TSG-RAN Meeting #13
Beijing, China, 18 - 21, September, 2001

TSGRP#13(01) 0600

Title: Agreed CRs to TS 25.435

Source: TSG-RAN WG3

Figure 5: Outer Loop Power Control Information Transfer procedure

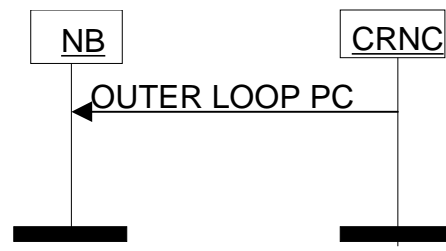
| Reason for change: | ⌘ Uplink inner loop power control for 1.28 Mcps TDD is closed loop as in FDD. So it is necessary to make the "Outer Loop Power Control" Frame Protocol procedure available for the respective uplink channels. Since these include not only DCHs but also USCHs, and for the USCH the Common Transport Channel Frame Protocol is applied, the "Outer Loop Power Control" shall be added to this protocol. |
| Summary of change: | ⌘ This CR adds the "Outer Loop Power Control" control frame and control frame type to the Common Transport Channel Frame Protocol. The coding of the control frame type "Outer loop power control" has been aligned with the coding applied in the DCH Frame Protocol (TS 25.427). Revision 1: Changes agreed at R3#23 (highlighted yellow): „SRNC“ is replaced by „CRNC“ in ch. 5.x; the additions follow the editorial rules applied in CR63/25.427 (R3-012366) and CR58/25.435 (R3-012368) |

5.x Outer Loop PC Information Transfer [1.28 Mcps TDD]

Based, for example, on the CRCI values and on the quality estimate in the USCH data frames, CRNC modifies the SIR target of the associated CCTrCH by including the absolute value of the new SIR target in the OUTER LOOP PC control frame sent to the Node B.

At the reception of the OUTER LOOP PC control frame from the CRNC via a Transport Bearer used for an USCH, the Node B shall immediately update the SIR target used for the inner loop power control for the respective CCTrCH with the specified value.

The OUTER LOOP PC control frame can be sent via any of the transport bearers carrying USCHs which belong to the CCTrCH for which the UL SIR Target shall be adjusted.

Figure 31: Structure of the payload for OUTER LOOP PC control frame

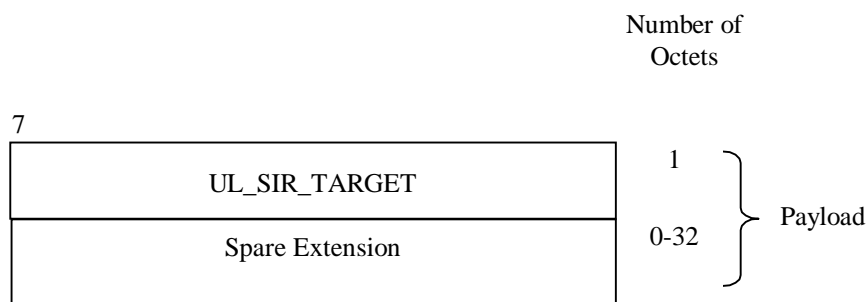
6.3.3.9 OUTER LOOP POWER CONTROL [1.28 Mcps TDD]

6.3.3.9.1 Payload structure

Figure below shows the structure of the payload when control frame is used for the UL outer loop power control.

6.3.3.9.2 SIR Target

Description: Value (in dB) of the SIR target to be used by the UL inner loop power control.

Value range: {-8.2...17.3 dB}.

Granularity: 0.1 dB.

Field length: 8 bits.

Figure 15: RACH Data Frame structure

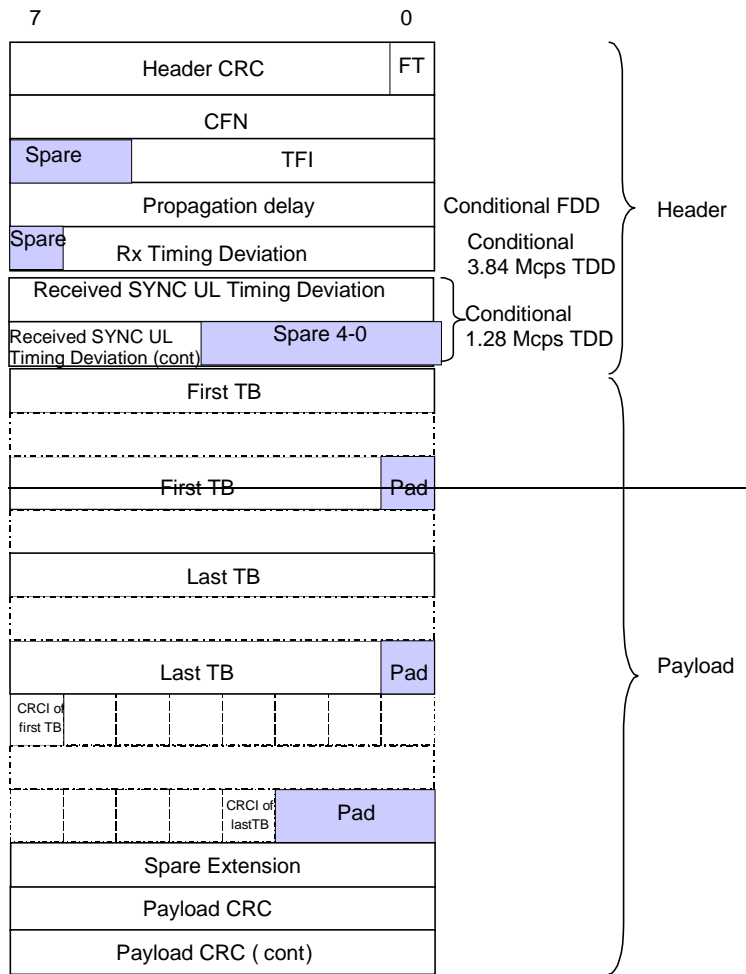
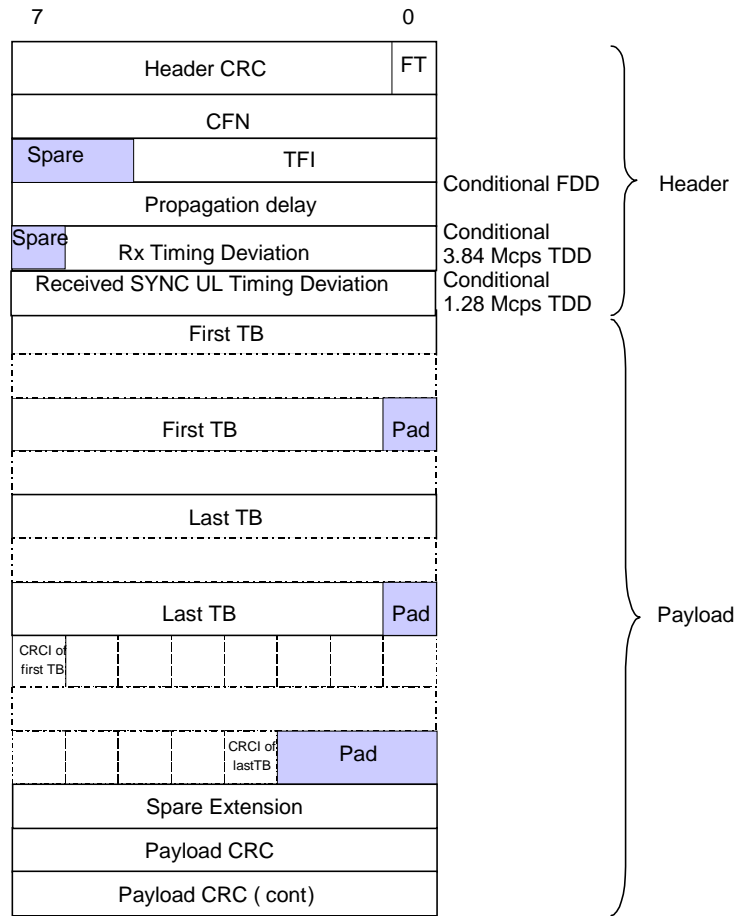
| Reason for change: | ⌘ It would simplify the implementation if the number of bits of 'Received SYNC UL Timing Deviation' (in the RACH data frame) is changed from 11 to 8 ,so that the number of octets in the RACH data frame header would be independent of the UTRA mode (FDD; HCR TDD, LCR TDD) . |
| Summary of change: | ⌘ 1. The figure of the RACH data frame is changed. 2. The number of bits of 'Received SYNC UL Timing Deviation' is changed from 11 to 8,and the resolution is changed from 1/8 chips to 1chip. |

Field length: 11-8 bits.

Figure 8: ~~FACH, PCH and DSCH~~ Transport Channels Synchronisation procedure

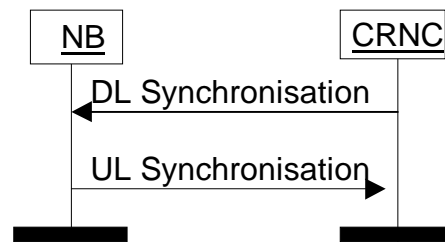
The procedure shall not be applied on transport bearers transporting UL traffic channels RACH or USCH.

Figure 9: ~~FACH, PCH, DSCH and [FDD - DSCH TFCI signalling]~~ Timing Adjustment procedure

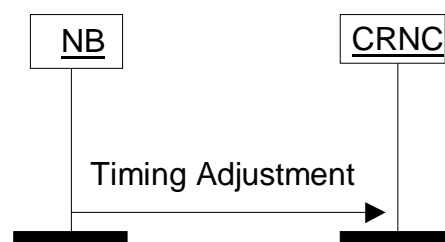
- 1) The association of the control frames and the transport bearers lacks clarification.
- 2) Uplink power control for 1.28 Mcps TDD requires corrections in the Common Transport Channel Frame Protocol
- 3) The combination of these two groups of corrections results in additional changes which are only visible in this merged CR.

Figure 5: Outer Loop Power Control Information Transfer procedure

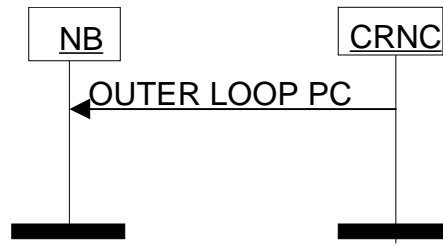
5.x Outer Loop PC Information Transfer [1.28 Mcps TDD]

Based, for example, on the CRCI values and on the quality estimate in the USCH data frames, CRNC modifies the SIR target of the associated CCTrCH by including the absolute value of the new SIR target in the OUTER LOOP PC control frame sent to the Node B.

At the reception of the OUTER LOOP PC control frame from the CRNC via a Transport Bearer used for an USCH, the Node B shall immediately update the SIR target used for the inner loop power control for the respective CCTrCH with the specified value.

The OUTER LOOP PC control frame can be sent via any of the transport bearers carrying USCHs which belong to the CCTrCH for which the UL SIR Target shall be adjusted.

Figure 31: Structure of the payload for OUTER LOOP PC control frame

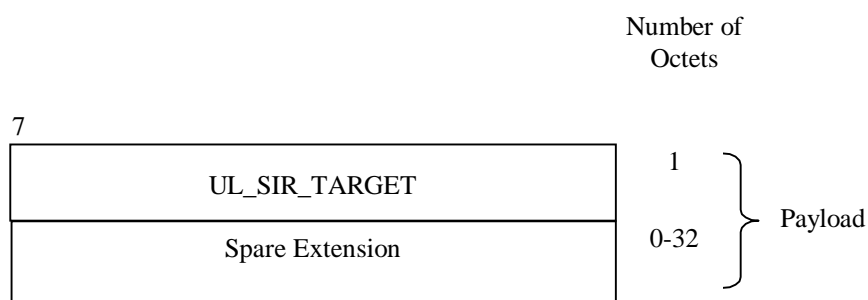
6.3.3.9 OUTER LOOP POWER CONTROL [1.28 Mcps TDD]

6.3.3.9.1 Payload structure

Figure below shows the structure of the payload when control frame is used for the UL outer loop power control.

6.3.3.9.2 SIR Target

Description: Value (in dB) of the SIR target to be used by the UL inner loop power control.

Value range: {-8.2...17.3 dB}, step 0.1 dB.

Field length: 8 bits.
